Re: **Application by – Perkins & Company Architecture and Urban Design Inc. at
4500 and 4600 Westwater Drive**

**Report to
Development Permit Panel**

File: DP 01-198029

Re: **Application by Perkins & Company Architecture and Urban Design Inc. for a
Development Permit at
4500 and 4600 Westwater Drive**

SECTION AA THROUGH PHASE 1 RAMP TO PARKING GARAGE

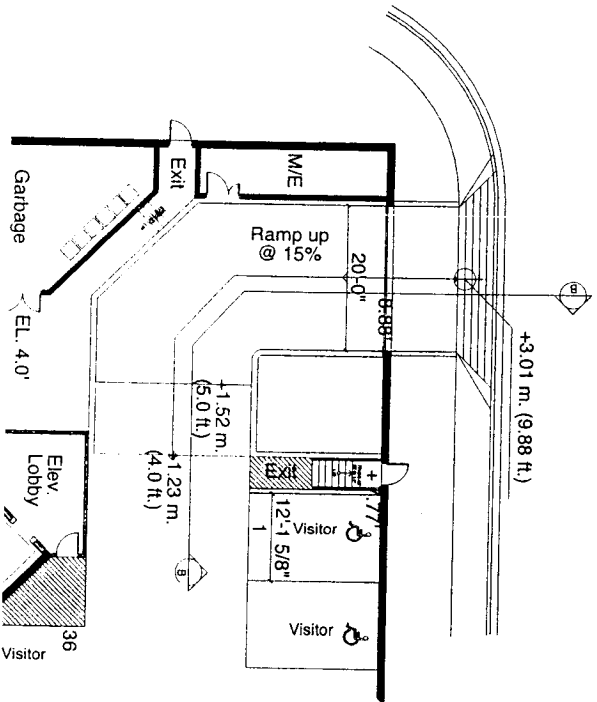
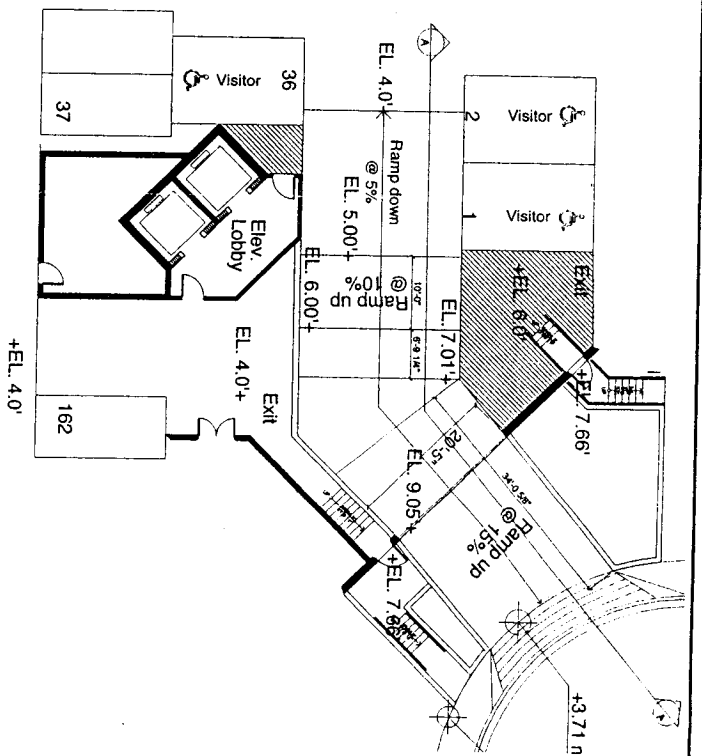
1. Identify any requested parking variances (i.e. tandem parking spaces). ***Parking variances are identified on the cover sheet of our resubmission.***
2. Provide an engineering cross-section of the entry ramp to the parking structure(s) and demonstrate that 'North American-size' vehicles will not contact or 'bottom-out' on the driveway during entry or egress. Provide the height of the overhead gates in the covered

- parking area and ensure adequate head room for typical 'sport utility vehicles'. *The applicant has provided a more detailed cross-section of the ramps to each parking garage.*

1 Typical Corner Section

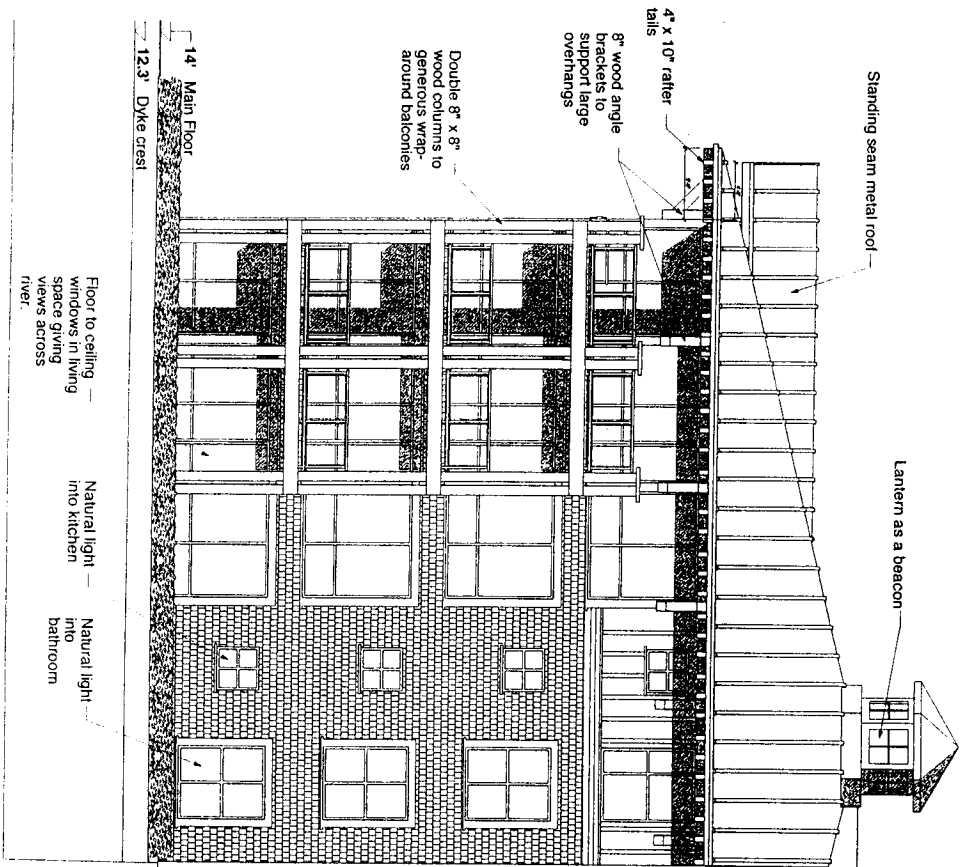
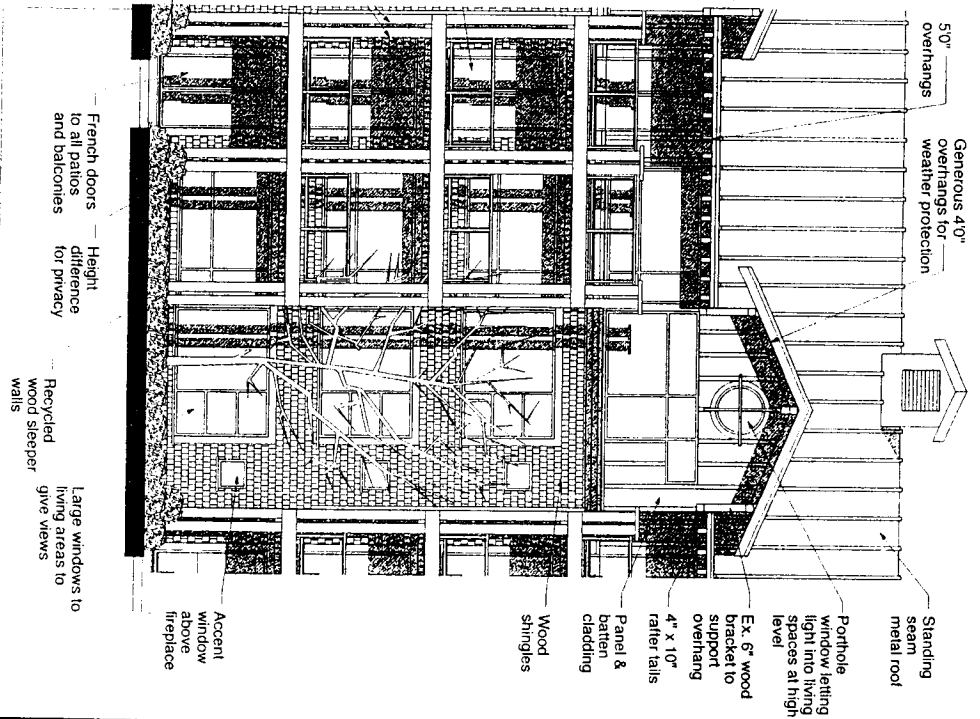
4. Provide additional architectural detailing for the structure of the balcony extensions at the south end of the 'L' shaped building wings. Consider the incorporation of heavy timber construction typical of the former cannery buildings and the use of timber framing complete with knee braces, metal brackets, connection plates and tie-rods. *The balconies will be detailed more fully at the working drawing stage. Rather than adding detail to the balconies, we have retained the simple metal railings and clear glass to reduce maintenance to these elements, ensure clear views across the Fraser River and to retain the elegant, clean lines of the design.*

7. Consider exaggerating the under-eave rafters, bracing, planking and bracket detailing. Submit more detailed architectural drawings of the under-eave detailing. *The applicant has amended the west end of the Phase 1 block (and this is reflected in the east end of the Phase 2 block) to make better use of the space internally and provide a more interesting elevation. It also removes the setback variance for the balcony at these ends. The exit stair has been relocated so that it is internal to the Westwater elevation, allowing the two (2) end units to make full benefit of the view of the Phoenix Pond to the west and the river to the east. Larger scale elevation studies are included in our resubmission to show the extensive use of timber and craftsman style details.*
